## Technical Bulletin

No.: RB660A01

Subject: Requirements for installing Z-Folding Unit ZF4000		Prepared by: H.Matsui		
From: 2nd Tech.	Support Sec. Service Support	Dept.		
Classification:	<ul> <li>Troubleshooting</li> <li>Mechanical</li> <li>Paper path</li> <li>Other ()</li> </ul>	<ul> <li>Part information</li> <li>Electrical</li> <li>Transmit/rec</li> </ul>		<ul> <li>Action required</li> <li>Service manual revision</li> <li>Retrofit information</li> </ul>

### Important Notes for When Installing the ZF4000 (B660-57/66/67) Z-Folding Unit on the D014/D015 Copier

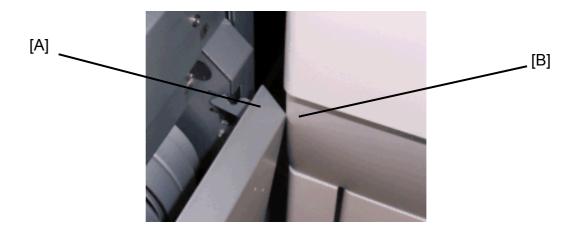
Note: If you connect a ZF4000 produced **before the cut-in S/N** to a D014/D015 copier (not supported), the following will occur:

- When jammed paper is removed from the ZF4000, the guide plate [A] will touch the copier front cover [B].
- A paper jam will occur if the ZF4000 is used with the B835-17 two-source cover interposer.

(1) The ZF4000 must be from <u>May 2007 production or later</u>.

ZF4000 machine code	Cut-in S/N	
B660-57	K3070400079	May 2007 production
B660-66	8M405700001	May 2007 production
B660-67	K3070500022	May 2007 production
